# Access Compliance Report

### (Curb Ramps)

Intersection ID: 20516	Main Street: OLD_PINEVILLE_RD	Cross Street: SILVERLEAF_RD	Location: NW
ADA ID: 23BB591475A6	Ramp Type: Directional1	Initial Pass/Fail: Fail	Overall Compliance: No
Severity Score: 12.5			
Codes/Mitigation Info/Possible Solution		Field Measurements/Component Compliance

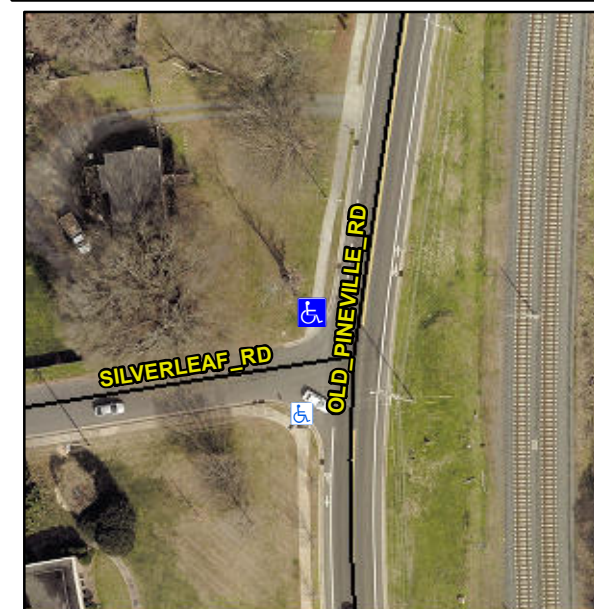
**R304.5.3**

Compliance	Description	Data	Compliance	Description	Data
N/A	Ramp Length (in)	79.0	N/A	Grade Break?	N/A
Yes	Ramp Width (in)	69.0	N/A	Grade Break Slope (%)	0.0
Yes	Ramp Slope (%)	3.9	N/A	Grade Break XSlope (%)	0.0
No	Ramp XSlope (%)	5.7			
N/A	Flare Type LT	N/A	N/A	Flare Type RT	N/A
N/A	Flare Slope LT (%)	N/A	N/A	Flare Slope RT (%)	0.0
N/A	Flare Traversable LT?	N/A	N/A	Flare Traversable RT?	N/A
N/A	Landing Length (in)	0.0	N/A	DWS Provided?	N/A
N/A	Landing Width (in)	0.0	N/A	DWS Contrast?	N/A
N/A	Landing Slope (%)	0.0	N/A	DWS Length (in)	N/A
N/A	Landing X Slope (%)	0.0	N/A	DWS Full Width?	N/A
N/A	Landing Curb? (Y/N)	N/A	N/A	DWS Offset LT (in)	N/A
N/A	Shared Landing?	N/A	N/A	DWS Offset RT (in)	N/A
N/A	Gutter Ponding?	0.0	N/A	Gutter Slope (%)	N/A
N/A	Gutter Lip Ht (in)	0.0	N/A	Gutter X Slope (%)	N/A
N/A	Painted X Walk1?	No		Road Slope (%)	4.2
	X Walk 1 Direction	To S		Road X Slope (%)	2.4
	X Walk 1 Width (in)	N/A		Clear Space?	N/A

**Remove & Replace Entire Ramp.**
